JOINT REGIONAL PLANNING PANEL (Sydney East Region)

JRPP No	2011SYE097
DA Number	MOD2012/0118
Local Government Area	City of Ryde
Proposed Development	Section 96(2) to amend the use of the hotel building and residential Building A to serviced apartments and associated design modifications.
Street Address	84-92 Talavera Road, Macquarie Park
Applicant/Owner	Meriton Property Services Pty Ltd Karimbla Properties (No. 29) Pty Ltd
Number of Submissions	Nil
Recommendation	Approval
Report by	Sandra Bailey, Team Leader Major Developments

Assessment Report and Recommendation

Figure 2. The above diagram demonstrates upper level of Building D. The red dotted line represents the footprint of the approved plant room.

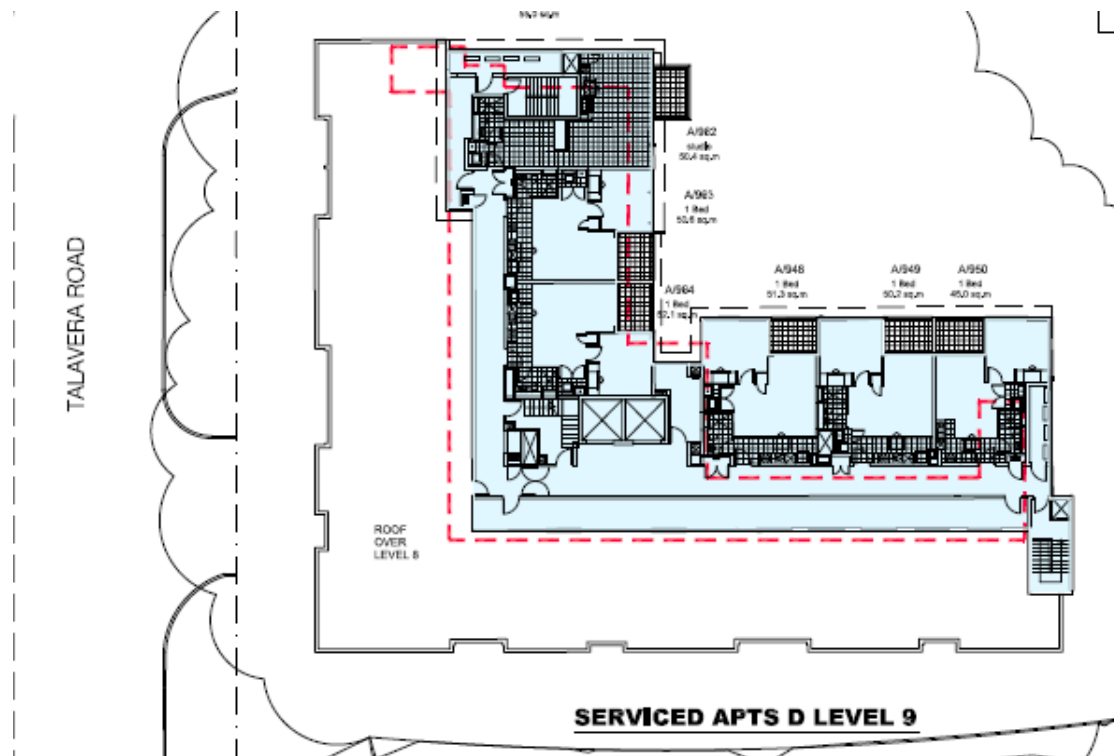
Figure 2 illustrates the area of the plant room floor that will be enlarged for Building D.

The approved plant room occupied 40.9% of the roof area. The enlarged floor plan will now occupy 53% of the roof area. The floor plan is being enlarged in the north western corner of this building. This will not be visible from either Talavera Road or Alma Road so there will be no change to the massing of this building as viewed from a public place. There will be no increase in overshadowing and no loss of amenity for the adjoining buildings as a result of this increase.

The height of Building D is still consistent with the heights approved in the development application with the exception of the lift overrun. The lift overrun is relatively minor in respect to the entire roof level and will not be visually prominent.

Figure 3. The above diagram demonstrates upper level of Building A. The red dotted line represents the footprint of the approved plant room.

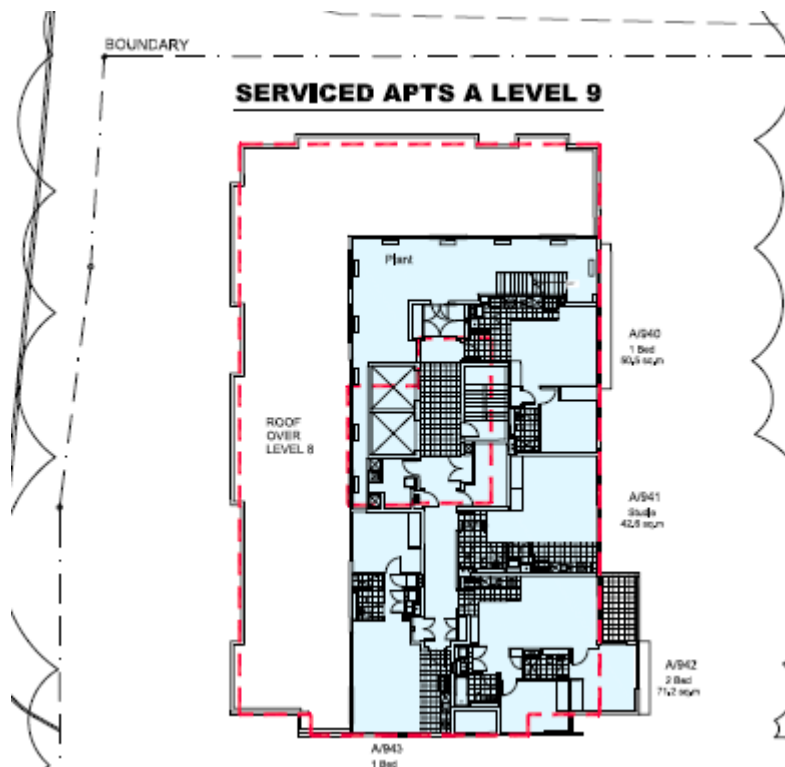
Figure 3 demonstrates the area of the building footprint that will be enlarged for Building A

The footprint for this floor will be enlarged from 9.3% to 57%. Despite the increased footprint of the upper level, the floor to ceiling heights in the building have been reduced. This ensures that the maximum approved RL is not exceeded for the development. To reduce the visual massing and appearance of this floor, it has been setback a minimum of 5 metres from the Talavera Road frontage and the M2 access road frontage. This setback will ensure that the additional massing will not impact on the streetscape. The height and massing of this building will not exceed the height of any future development on the Macquarie Shopping Centre site. As such this building is still consistent with the desired character of the area.

Building separation distances are also adequate to ensure the amenity of Building B will not be affected. Also no additional overshadowing will occur as a result of this change.
